CIRCULATE TO:  
SERVICE MANAGER   
PARTS MANAGER   
MECHANICS   
"Place in a Service  
Bulletin Binder"

## PROPELLER INTERFERENCE WITH TRIM TAB ON MERCUISER I STERN DRIVES

**Figure 1. Checking Propeller to Trim Tab  
Clearance**

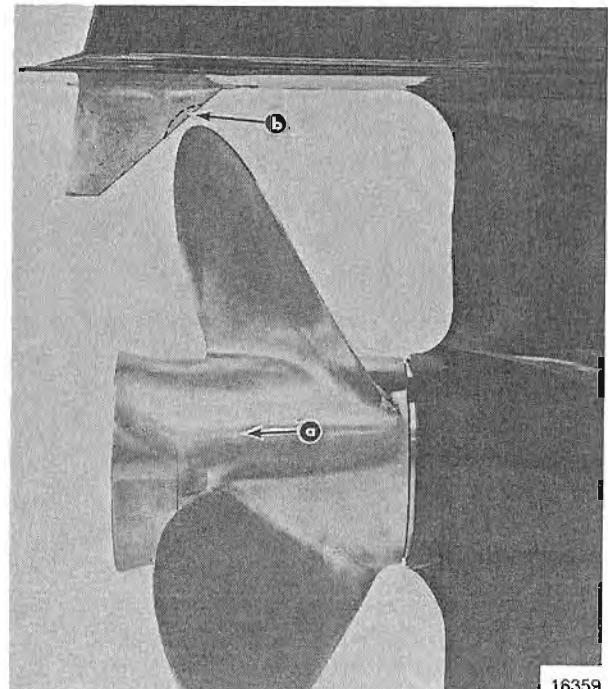
To check for adequate clearance, pull propeller rearward while checking clearance between trim tab and each propeller blade. (Figure 1) A minimum of .100" (3/32" or 2.54mm) clearance should exist. If clearance is insufficient, check for the following:

- That short trim tab (31640A1) is being used. Use of long trim tab (34127A1) will cause interference.
- That forward thrust hub (77987) is being used. Use of forward thrust hub (56292A1 or A2) will cause propeller interference.
- That spline washer is engaged with splines on propeller shaft. Failure to mate splines will prevent propeller nut from drawing propeller into proper position on shaft.
- That propeller nut is torqued to 55 lbs. ft. (74.6 N.m) minimum.

- a - Pull Propeller Rearward
- b - Remove Material from This Area Of Trim Tab  
If Clearance Is Less Than .100" (3/32" or 2.54mm)

If none of the preceding are the cause for interference, the trim tab **MUST BE** modified to provide sufficient clearance. Remove stock from trim tab with a file or a grinder, at location shown in Figure 1. Do not remove any more stock than absolutely necessary.
